Draft Environmental Impact Statement Public Comment Form

SOUTH MEDFORD INTERCHANGE PROJECT
ALTERNATIVES & SOLUTIONS

SOUTH MEDFORD INTERCHANGE
HIGHLAND ALTERNATIVE
JANUARY 30, 2002
PRELIMINARY - SUBJECT TO CHANGE

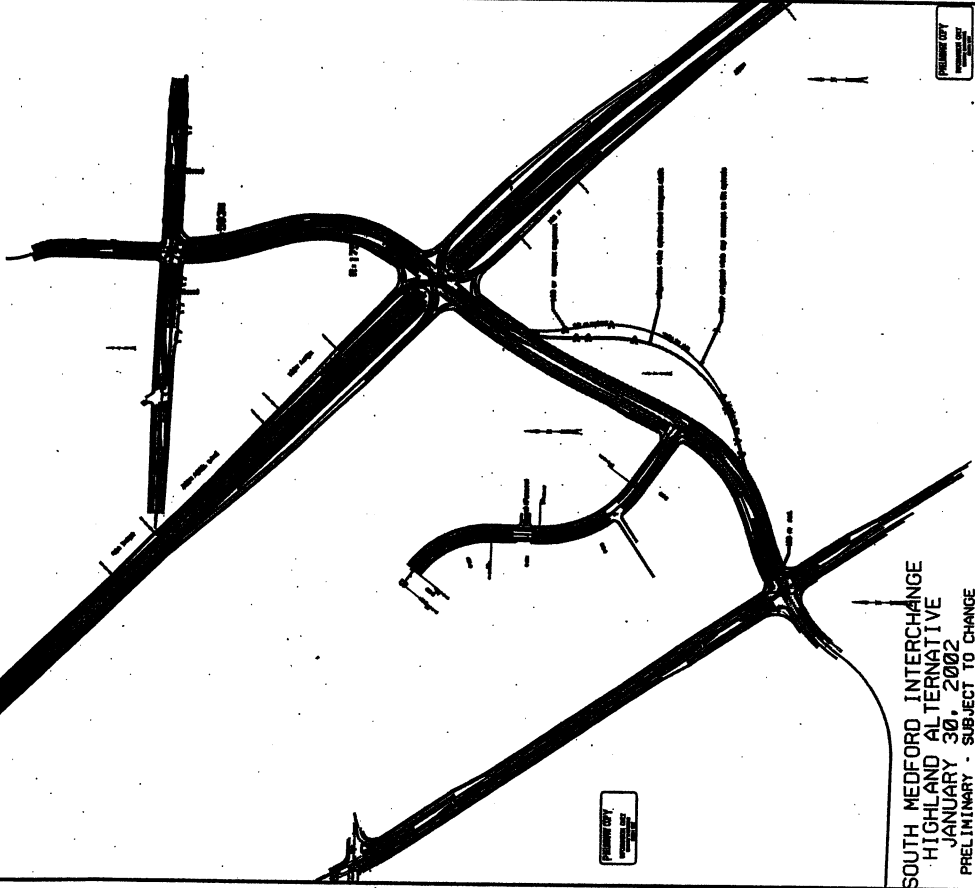
Original Design vs. Southerly Shift

- Approaches to SPUI and Center Drive nearly tangent, promoting superior signal head visibility
- Right-on-red turn out of Center Drive has superior sight distance for decision making
- Center Drive intersection spaced 400 meters from ramp terminals, meeting standard
- Minimizes right-of-way impacts to existing structures
- Less overall length of roadway equates to reduced travel time and construction cost

- Provides slightly better approach to Hwy 99 intersection in that vehicles will be able to see the signal heads from farther away
- Provides additional 312 square meters (3358 square feet) for future development north of Center/Garfield intersection
- Increases size of remainder property east of RFCU

- Requires major deviation for intersection spacing from interchange ramp terminal (Div. 51)
- Increased impacts to existing structures (Hale) (PP&L cost ~ \$2,000,000)
- Reduces sight distance at Center Drive intersection (to signal heads and for right outs)
- Intersection area will be larger to accommodate truck off-tracking, results in longer crossing distance for pedestrians
- Reduces sight distance at SPUI intersection
- Longer overall roadway length and construction cost
